**Title: CONTINUED AIRWORTHINESS FOR CONNECTING ROD ASSEMBLIES**

Issued: **05/13/04**

Revision: **2 (9/23/04)**

Figure 1: The number markings on one side identify the orientation of the rod and cap at assembly.

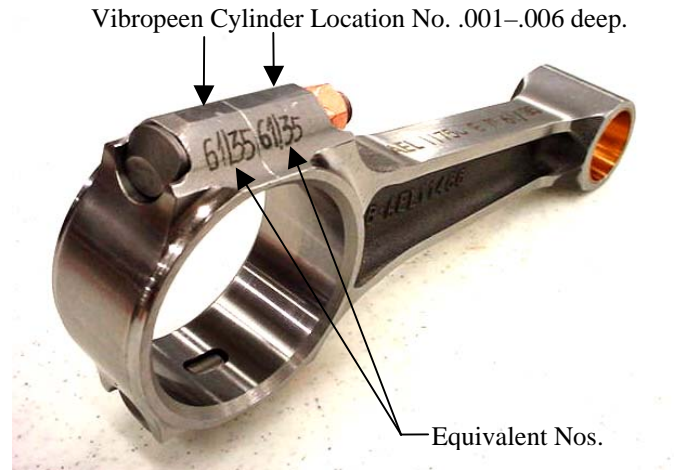
Traditionally, ECi has sold connecting rods in the unassembled state as a unit consisting of a rod and a cap. These two separate units of the same part are identified by number markings such that they should be assembled in only one way (see Figure 1 below). However, a mechanic unfamiliar with this may assemble the rod and cap rotated 180°, which may or may not yield a circular big end bore.

Because of this potential problem, ECi began selling connecting rods in the assembled state in April 2004. This assembly includes the rod and cap assembled with connecting rod bolts and nuts torqued to required values. This method serves two purposes. First, the mechanic understands precisely how the rod and cap must be reassembled onto the crankshaft. Second, it allows the mechanic to inspect the diameter of the big end bore without having to assemble the rod and cap. All ECi connecting rods are now sold in this configuration.
